Item 4(b) of the provisional agenda

Proposal for a new amendment to UN Global Technical Regulation No. 4 (World-wide harmonized Heavy Duty Certification procedure (WHDC))

Submitted by the expert from Japan*

Figure 12

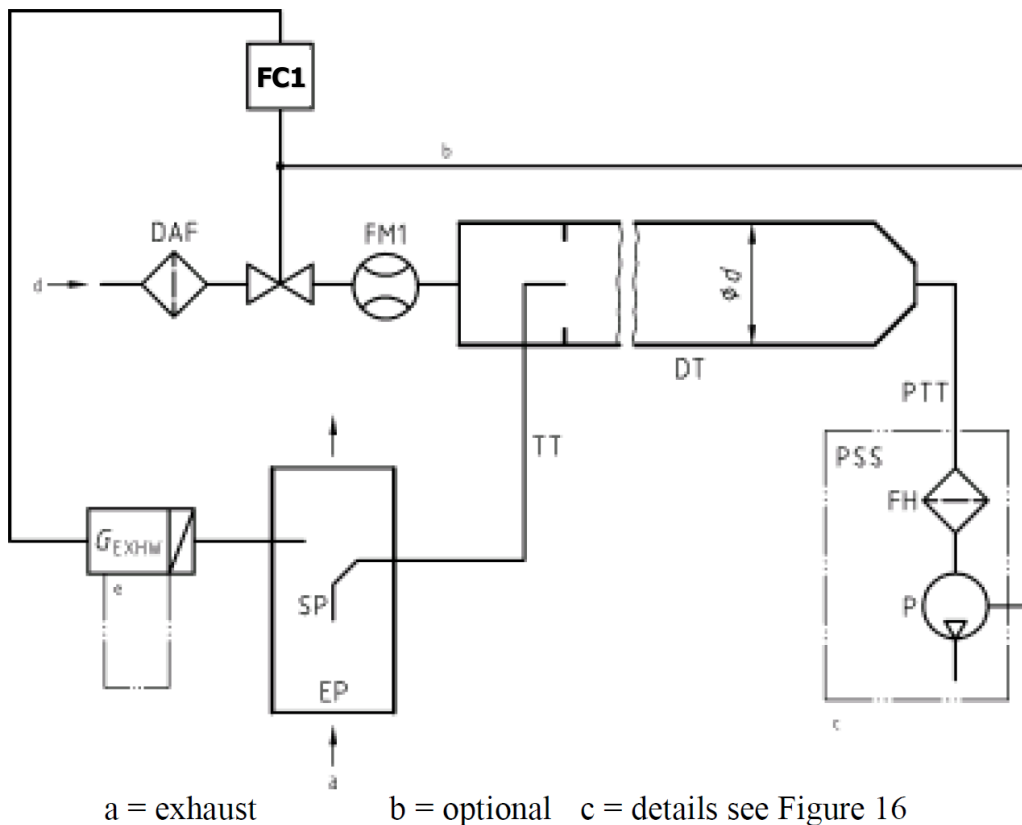
Annex 3, paragraph A.3.2.1. Figure 12, *amend to read:*

9. Annex 3, paragraph A.3.2.1.

In the text, the flow controller is represented by “FC1”, whereas in Figure 12, it is “FC2”. Therefore, it is necessary to correctly set “FC1” in Figure 12.
